LAND USE BOARD APPLICATION

60 Bay Ave Highlands LLC is seeking revision of its Preliminary and Final Major Site Plan Approval memorialized by Resolution 2024-16, dated September 12, 2024, to raise and expand the existing three-story multi-family residential building on property located at 60 Bay Avenue and identified as Block 42, Lot 1 on the Borough's tax maps (the "Property"). The Property is approximately 6,425 square feet, or 0.147 acres, and is located in the Central Business District (CBD) within the CBD Redevelopment Area Overlay 2 Zone. Five multi-family units are still proposed comprising of 4-two-bedroom units and 1-three-bedroom unit.

Application:	60 Bay Avenue Multifamily Residence	Municipality:	Highlands
Applicant:	60 Bay Avenue Highlands, LLC	Municipal Agency:	Planning Board
Owner:	Applicant	Block:	42
Design Professional:	InSite Engineering	Lot:	1
Plan Date:	2/20/2025	Date Received:	3/7/2024
Project Description:	Additional apartment and off-street parking at existing multifamily residence		
Action Taken By:	X Development Review Committee Planning Director	Approval Status:	REQUEST INFORMATION
		Action Date:	3/24/2025

PRELIMINARY & FINAL MAJOR SITE PLAN FOR PROPOSED

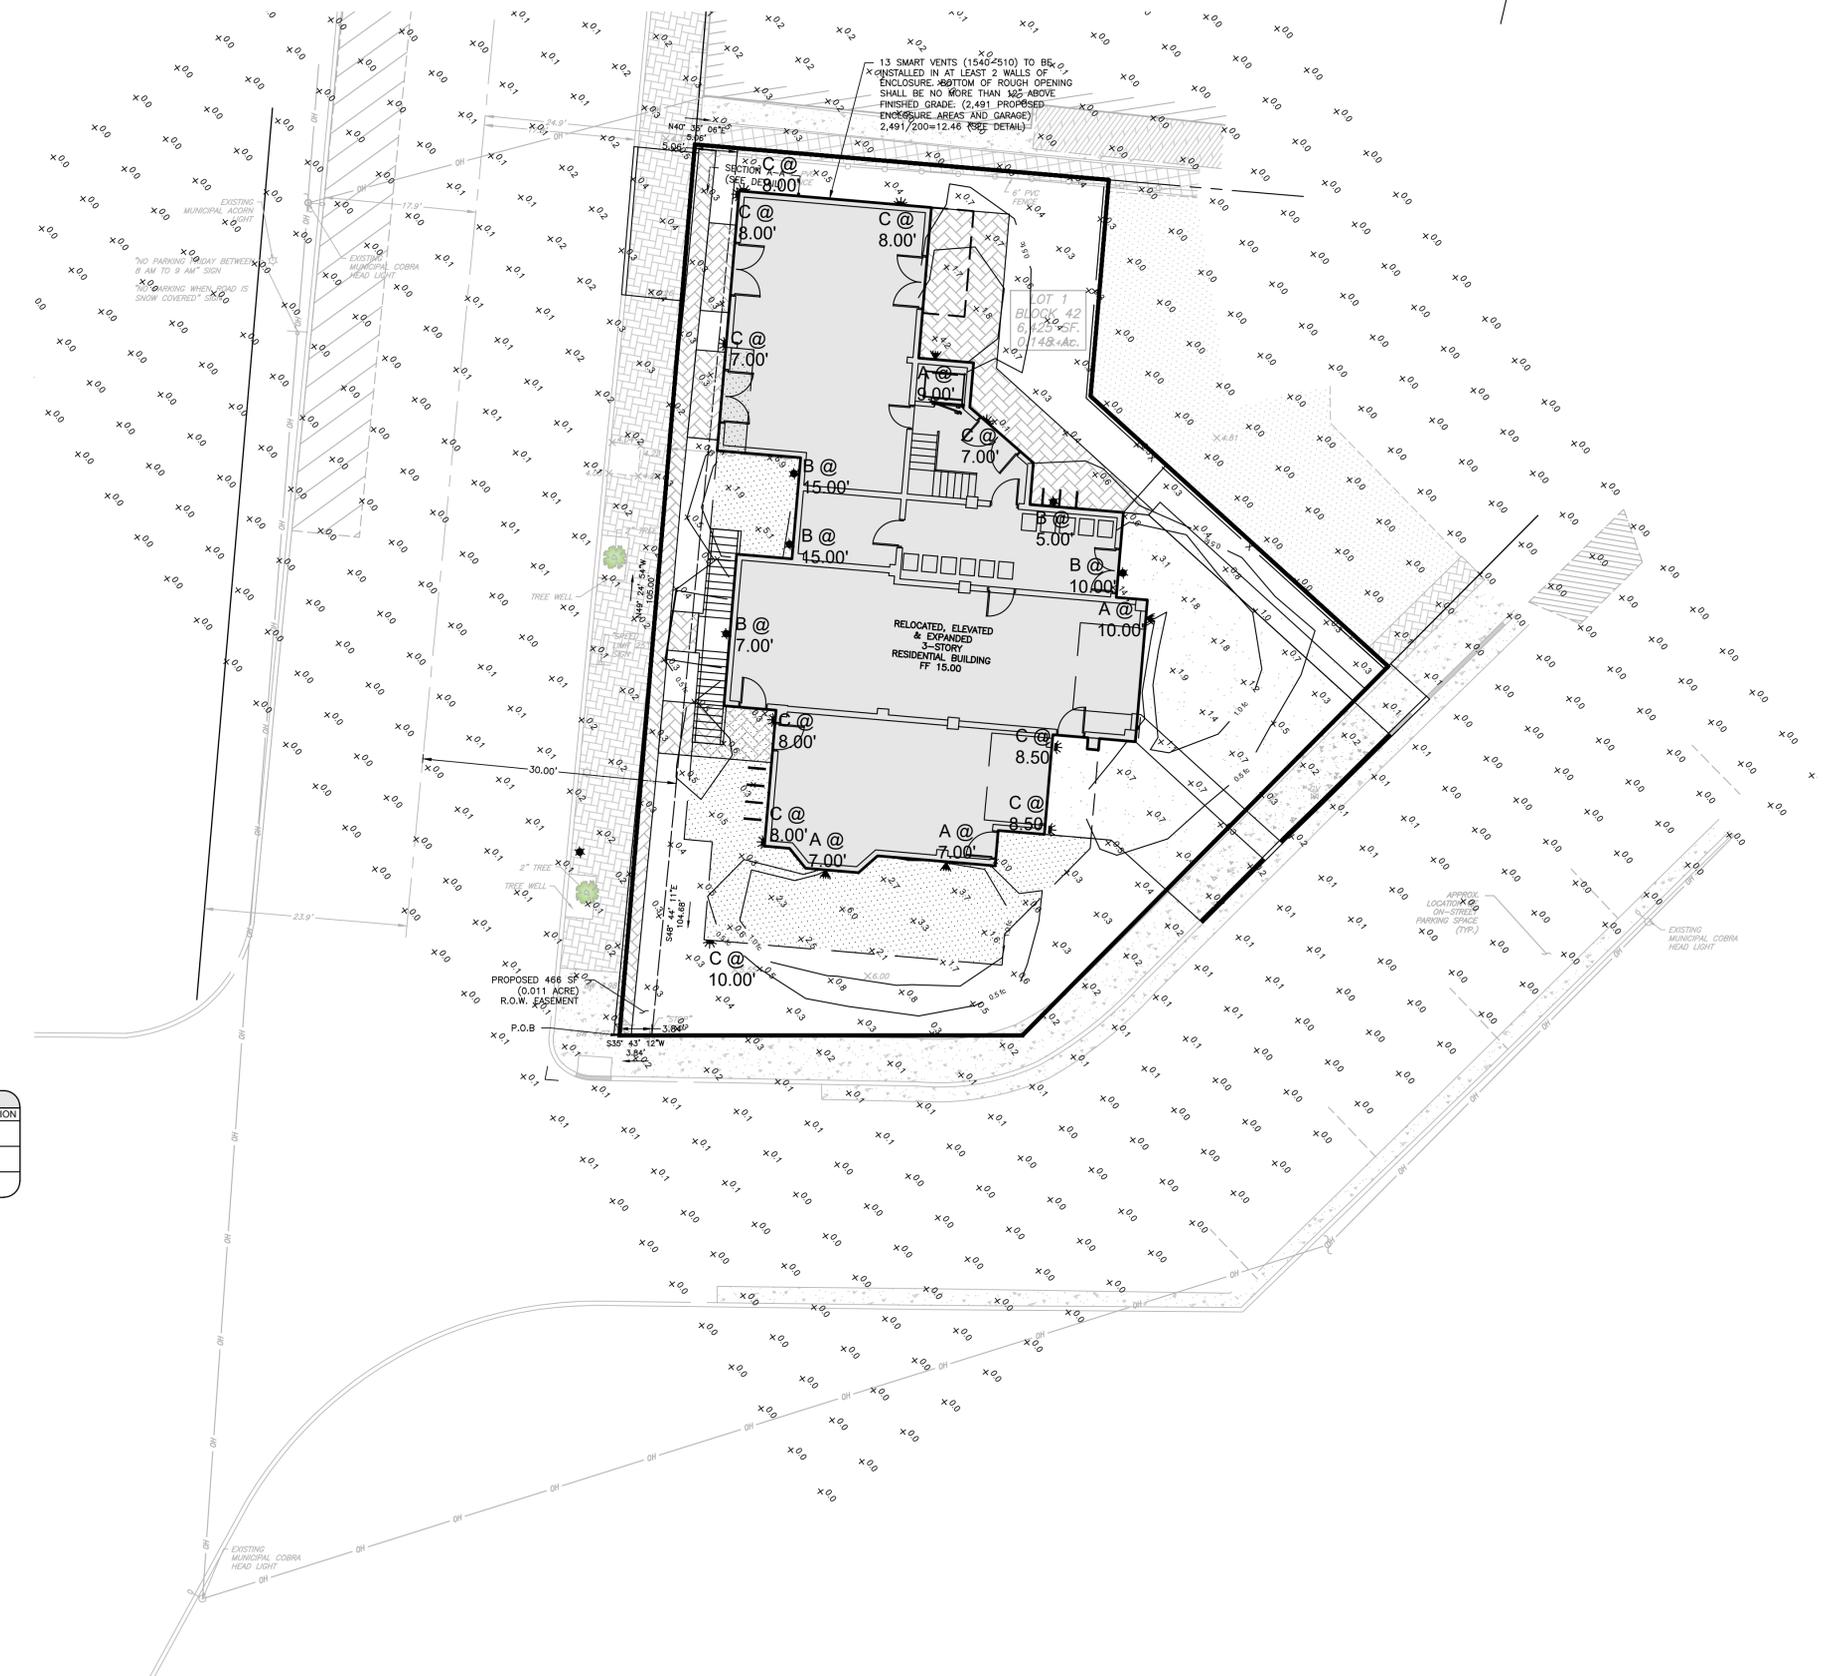
GC5. The Site Layout Plan, sheet C300, has several discrepancies:

The proposed width between two of the more proximate residential driveways (NW) fronting C.R. 8, Bay Avenue is 5 ft. The setback for closest (NW) access driveway is 8 ft. The proposed driveway designs do not satisfy Monmouth County Design Regulations and should be revised for compliance.

Comment from 1/13/25 memo: The revision of the driveway configurations to a shared driveway satisfies the 25' minimum between spacing between driveways. However, the 5-ft apron flare is within 10-ft of the property line. Per Monmouth County Development Regulations, vol. 2, §5.2-3.1I, driveway apron flares and corner radii are considered as portions of the driveway.

PARTIALLY ADDRESSED: The Site Layout Plan indicates the apron flares do not comply with MCDR §5.2-3.1I and will require a waiver request from the Development

Review Committee. Support for the request can be recommended based on the applicant's modifications to the driveway fronting C.R. 8 which were requested by the County.
